Sedan Range

19.7-01

## **TECHNICAL BULLETIN**

### **Powertrain 4L80-E Transmission – Noisy Rear Mount – Modification Procedure**

ILLUSTRATION 1

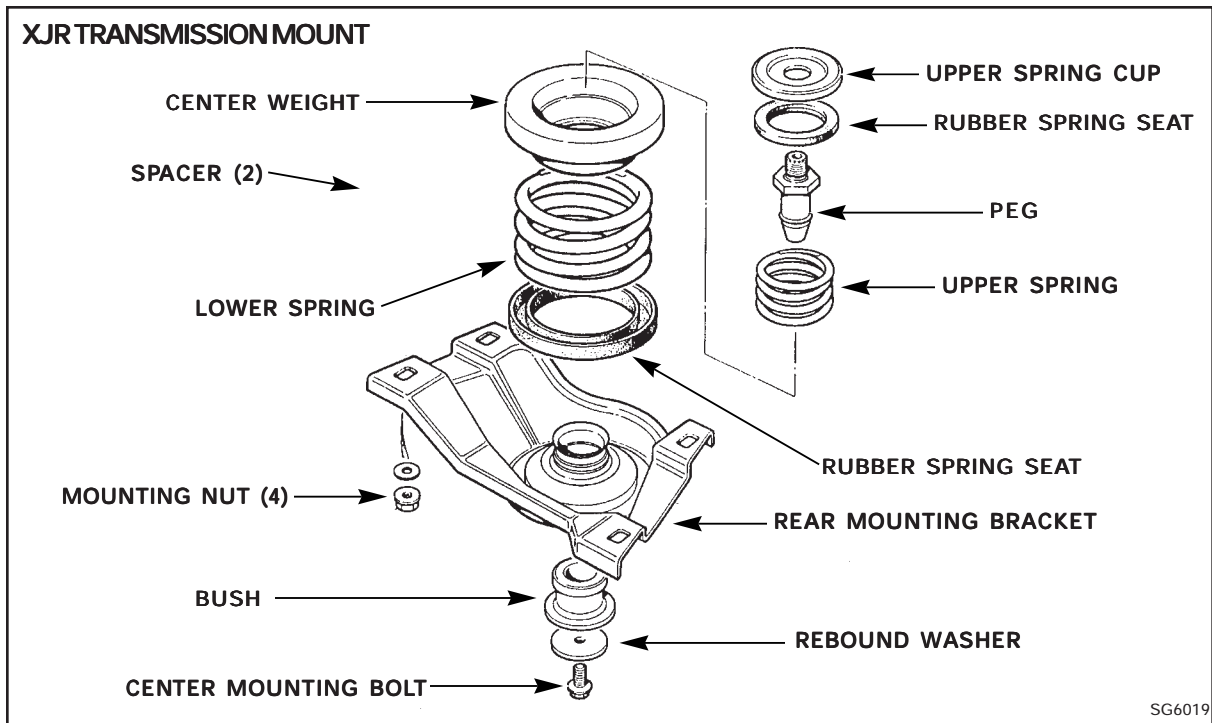
Some vehicles equipped with Powertrain 4L80-E transmissions within the above VIN ranges, may exhibit a knock or squeak from the area of the transmission tunnel. The noise may be traced to movement of the damper peg of the rear transmission mounting against the surrounding foam bush.

An improved peg and bush was introduced in production from VIN 734672 for the XJR and 738562 for the XJ12.

5. Align tool set MS53 on the fender channels and with the rear lifting bracket. Tighten the nut of the support hook to support the engine.
6. Raise the vehicle and remove the center mounting bolt (illustration 1) and the rebound washer from the transmission mount.

13. Install the replacement peg with the upper spring cup on the transmission. Torque the peg to 67.5 - 81.5 lb ft (90 - 110 Nm).
14. Install new upper and lower rubber spring seats to the upper and lower springs.
